April 17, 2013

PROJECT : Wayside Elementary School Modernization
Schematic Design - Community Meeting #3
PROJECT NO. : 530275.000

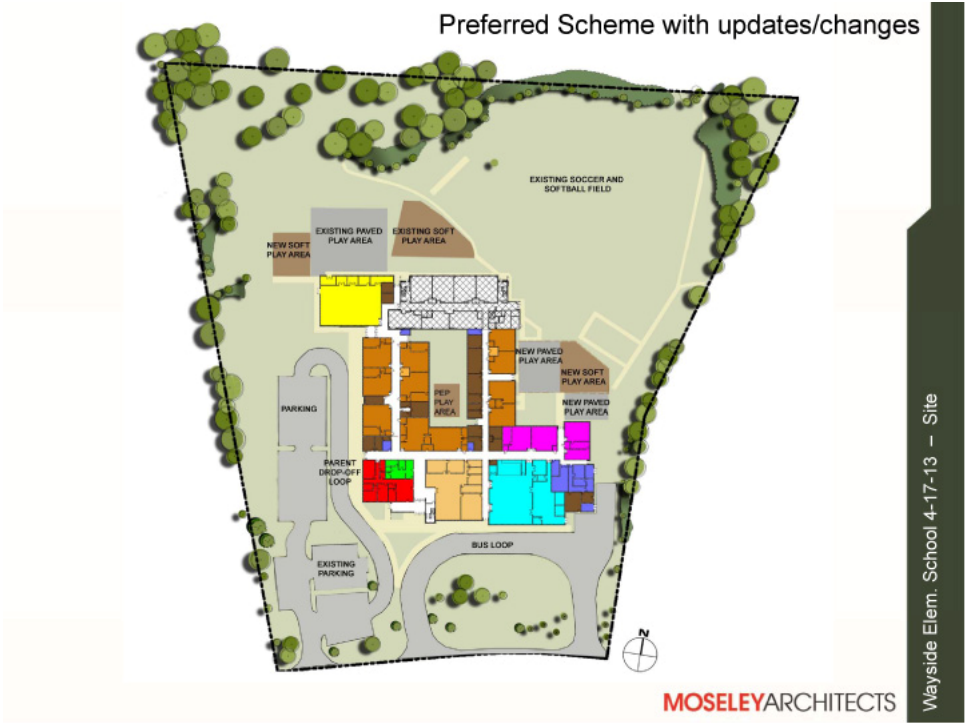
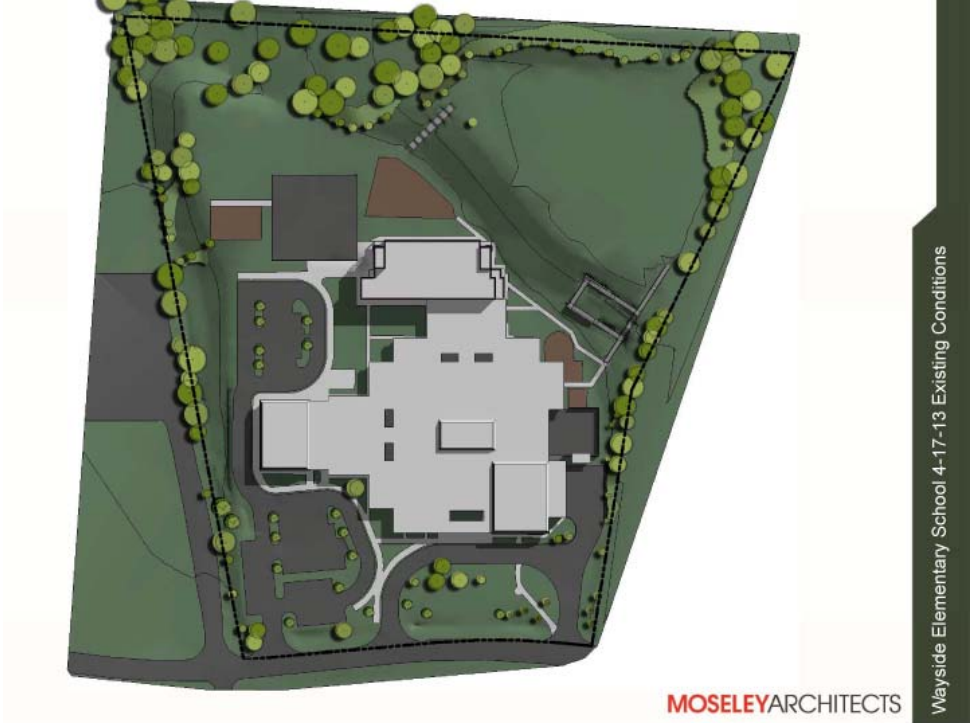
3.	Mr. Brown began the powerpoint presentation and explained that these meetings are sequential and do build on each other. Meetings are at alternating times to allow participation by both the community and the school. He then went on to the site plan and described the changes, including the revised bus loop, going from a 1 story to a partial 2 story building but still keeping the 2 story portion adjacent to the pool property and away from the adjacent houses. Also noting that with the	-- --

existing grade changes on the site and the building footprint change we are able to provide additional play spaces closer to the building on the west side.

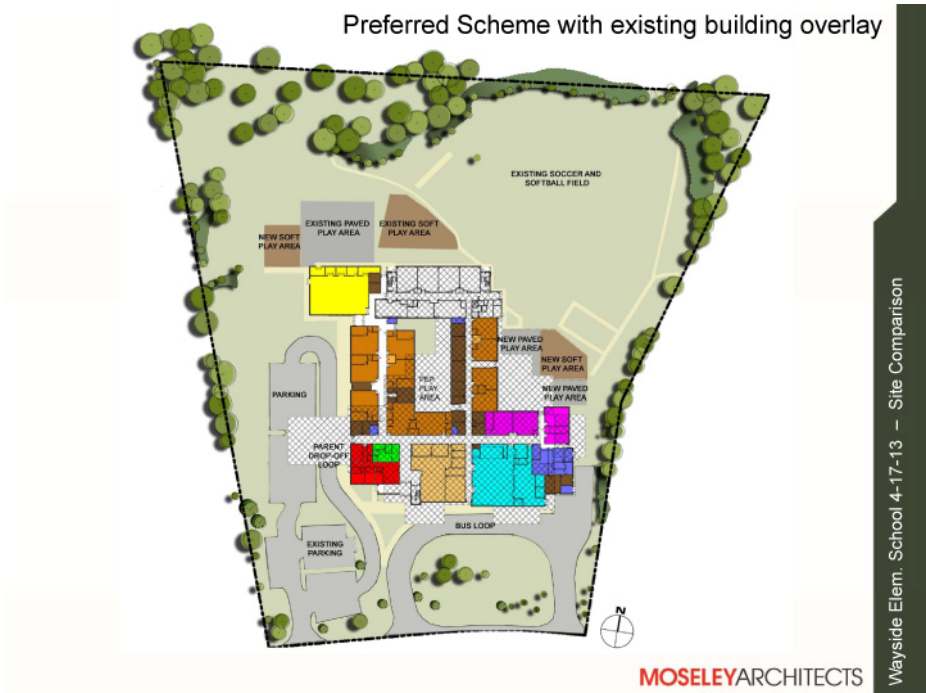
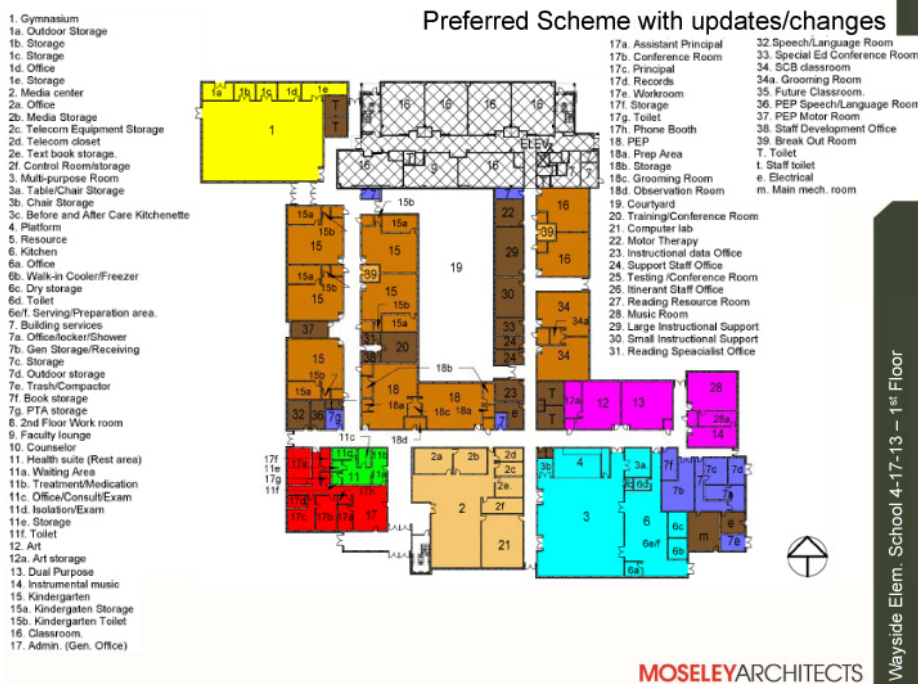
4. Ms. Brookman followed with presenting the revised floor plans. She noted that the SCB rooms have shifted as well as the PEP classrooms to meet state regulations that require them to be located with their peers. Ms. Storms questioned if there was a way to separate them to provide a view into the courtyard from the media center or entrance? Ms. Morris stated that it is possible to divide the PEP rooms but that they do share many common spaces and it is not as desirable.

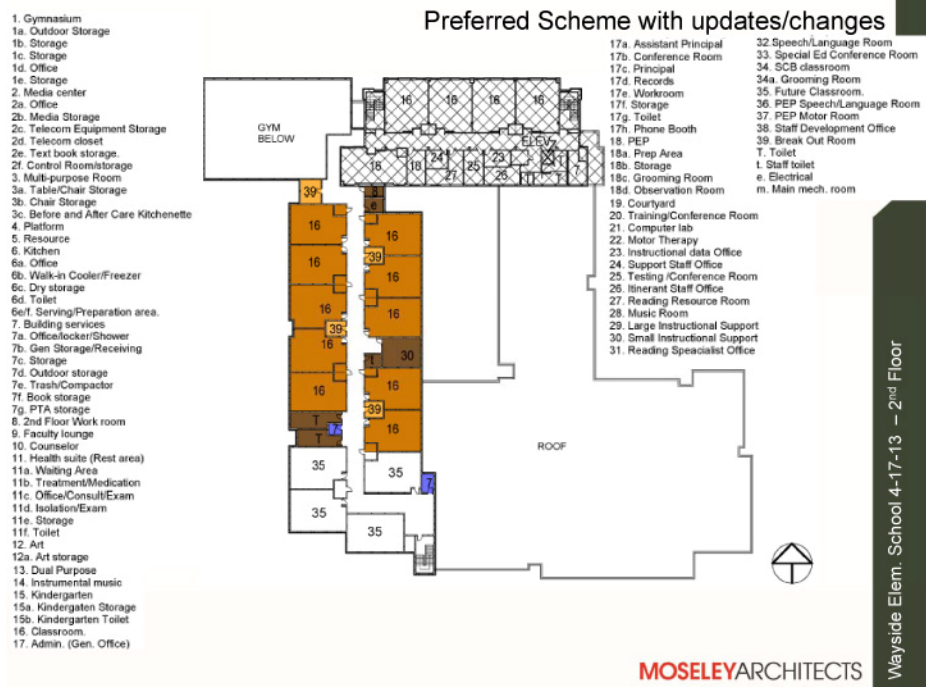
5. The Break Out rooms were presented to the group as shown on the plans and it was mentioned that there are similar rooms at Carderock Elementary School. The rooms would be located between two classrooms where feasible and have windows into the Break-Out rooms from both adjacent classrooms. The door to the Break-Out rooms would be off the corridor but not directly from within the classrooms. The small rooms would have doors. If the school opted to not have the Break-Out rooms then the pair of classrooms would have a connecting door between them for collaboration. -- --

- There was a lot of discussion regarding the potential use of the rooms and if they would be a good fit or not at Wayside. The Teachers expressed doubt that they would be able to use them in a similar fashion to the current pod concept use. The school decided to contact Carderock Elementary School to see how the spaces are being used currently in order to help make a decision if they are desirable or not. The feel was that the building as presented lacked the special connections made possible in the current pod design of the school and that a greater potential for collaborative learning with supervision from the classrooms was desired in the modernized building. The Architectural team agreed to look at potential options within the building while still meeting the MCPS guidelines, and prepare larger drawings showing the furniture layouts within the classrooms with and without the Break-Out rooms to help with the decision making process.

6. Ms. Storms commented on the lack of views to the courtyard from the surrounding corridors. She would like to see the design team try to find a way to keep the courtyard connection to the corridors to help give community ownership to the courtyard and allow the whole school not just the adjoining classrooms to see into the area and promote use by the larger school body. The courtyard may have the PEP play areas included but would be for use by the whole school. The school and the PTA will be responsible for what activities, outdoor learning opportunities etc. occur in the area. -- --
